Project	IEEE 802.16 Broadband Wireless Access Working Group < http://ieee802.org/16 >	
Title	H-FDD Frame Structures for the AAIF and Legacy Supports	
Date Submitted	2009-07-06	
Source(s)	Dongguk Lim, Sungho Moon, HanGyu Cho, Jin Sam Kwak	Voice: +82-31-450-1882 E-mail: dongguk@lge.com , msungho@lge.com , hgcho@lge.com , samji@lge.com
	LG Electronic Inc. LG R&D Complex, 533 Hogue-1dong, Dongan-gu, Anyang, 431-749, Korea	
Re:	Re: IEEE 802.16m-09/0028r1 Call for Comments and Contributions on Project 802.16m Amendment Content - Call for Comments and Related Contributions on Amendment Working Document	
Abstract	The contribution proposes the text of frame structure section to be included in the 802.16m amendment.	
Purpose	For discussion and approval by TGM for 802.16m amendment.	
Notice	<i>This document does not represent the agreed views of the IEEE 802.16 Working Group or any of its subgroups. It represents only the views of the participants listed in the "Source(s)" field above. It is offered as a basis for discussion. It is not binding on the contributor(s), who reserve(s) the right to add, amend or withdraw material contained herein.</i>

H-FDD Frame Structures for the AAIF and Legac

Figure x AAIF H-FDD frame structure

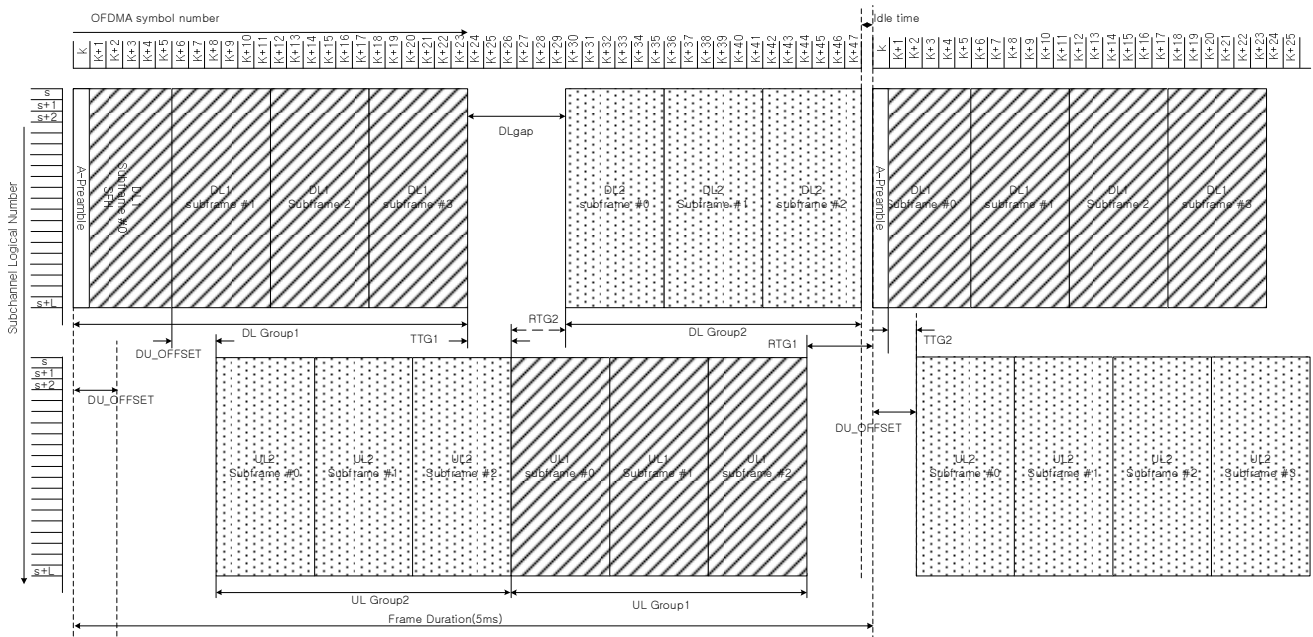
===== Start of Proposed Text =====
 [Remedy 1: insert the new text in line 37 on page 118:]

The H-FDD frame structure is based on the F-FDD frame structure defined 15.3.3.1. The AAIF H-FDD MSs are classified into two groups, i.e., H-FDD group1 and H-FDD group2. Each frame is also divided into two time zones in DL and UL in the units of subframes. The DL subframes for H-FDD group 1 (DL1) is comprised of A-Preamble, SFH, A-MAP, and data symbols. The DL subframes for H-FDD group 2 (DL2) is comprised of A-MAP and data symbols.

Figure x illustrates the example of H-FDD frame structure for supporting AAIF H-FDD MSs. As shown in the Figure x, TTG1, TTG2, RTG1, and RTG2 for each H-FDD group denote the switching intervals between DL and UL zones. One or more idle subframes in DL and UL for AAIF H-FDD MSs shall be assigned for accommodating the transition intervals and for receiving the DL control signals. An idle DL subframe is used for occupying a gap DL_{gap} between two DL zones. The last UL subframe in a frame is idle for transition time between DL and UL zones. The first UL subframe in a superframe for all AAIF H-FDD MSs shall be also idle for receiving SFH in the first DL subframe of a superframe. DU_OFFSET denotes a positive or negative time difference of UL frame relative to DL frame in the unit of OFDM symbol as shown in figure x. The DU_OFFSET value is adjustable for the idle DL and UL subframes to be used for support the transition gap and the reception of the DL control signal.

Figure xxx AAIF FDD frame configuration for supporting the legacy H-FDD

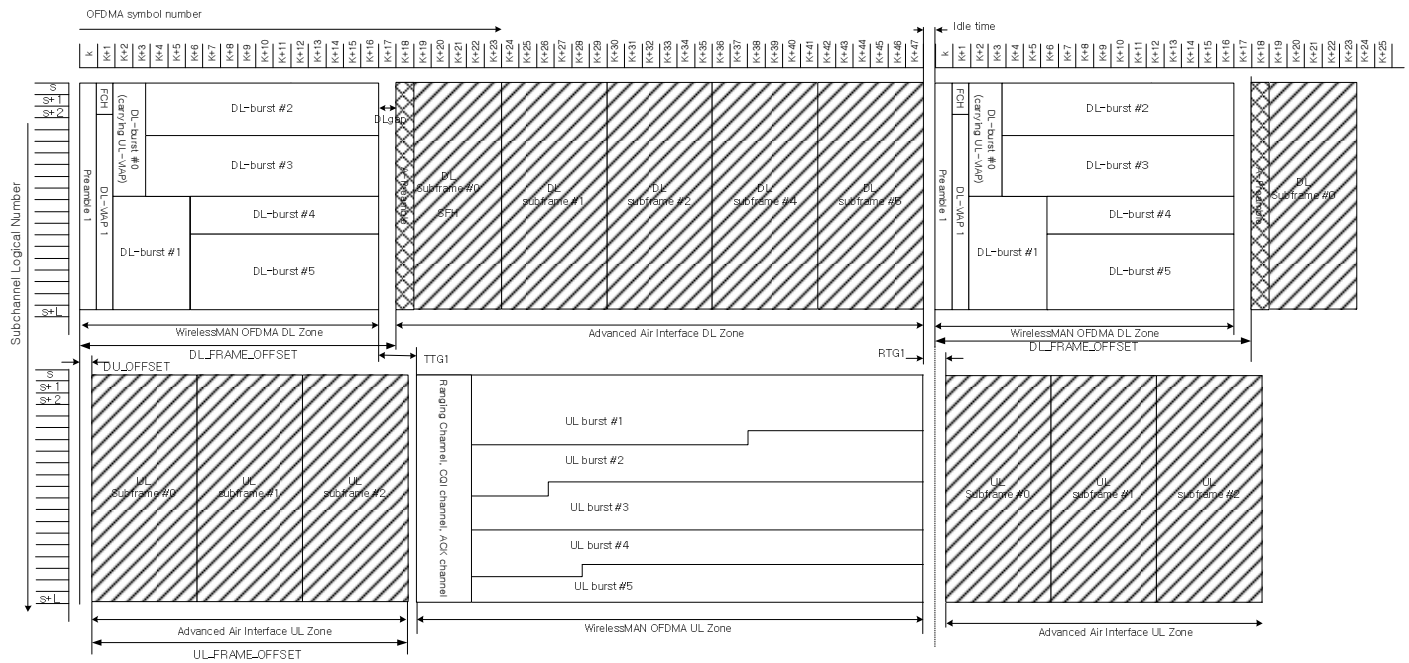
[Remedy 2: insert the new text in line 41 on page 130:]

The FDD frame structure is separated two regions in the DL and UL for supporting the coexistence of the WirelessMAN-OFDMA H-FDD MSs and AAIF full-FDD MSs in the same frame.

The WirelessMAN-OFDMA H-FDD frame and AAIF FDD frames can be offset by a fixed number of subframes. The DL_FRAME_OFFSET is defined as the starting DL subframe for AAIF and UL_FRAME_OFFSET is defined as the time duration for the AAIF UL zone. In this case, the DU_OFFSET can be set as DU_OFFSET=0.

Figure xxx illustrates an example of the frame configuration for supporting the mix of WirelessMAN-OFDMA H-FDD and AAIF F-FDD for 5, 10, 20MHz with a CP length of 1/8 T_b.

Figure xx AAIF H-FDD frame structure for supporting the legacy H-FDD

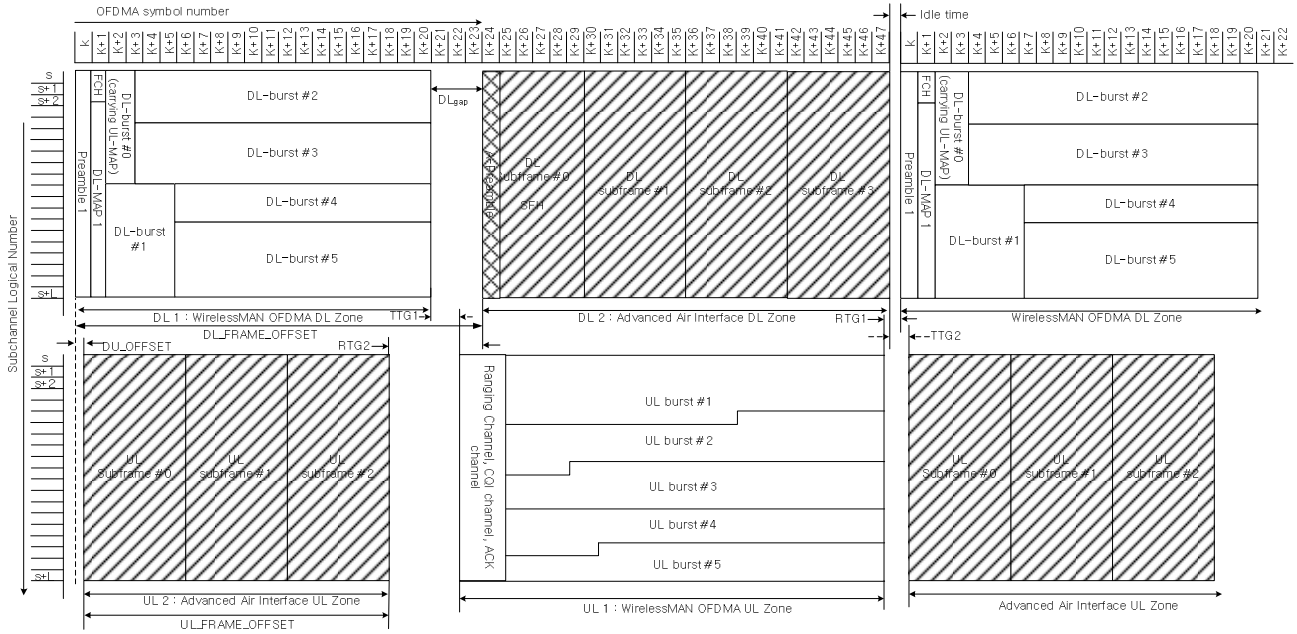
The WirelessMAN-OFDMA H-FDD MSs and AAIF H-FDD MSs are supported by using the H-FDD frame structure defined 15.3.3.2.2.1.1. The distinct partition of a 5ms frame for group 1 can be allocated to legacy H-FDD MSs. The DL subframes for group 1 (DL 1) is comprised of Preamble, MAP and data symbols. The DL subframes for group 2 (DL 2) is comprised of A-Preamble, SFH, A-MAP and data symbols.

Figure xx shows the H-FDD frame structure supporting the WirelessMAN-OFDMA H-FDD for 5, 10, 20MHz with a CP length of 1/8 T_b. All subframes in DL and UL AAIF zone are type-1 subframes irrespective of the DL and UL zone

partitions. The last UL subframe in the AAIF UL zone is set as an idle UL subframe for the UL to DL transition of AAIF H-FDD MSs.
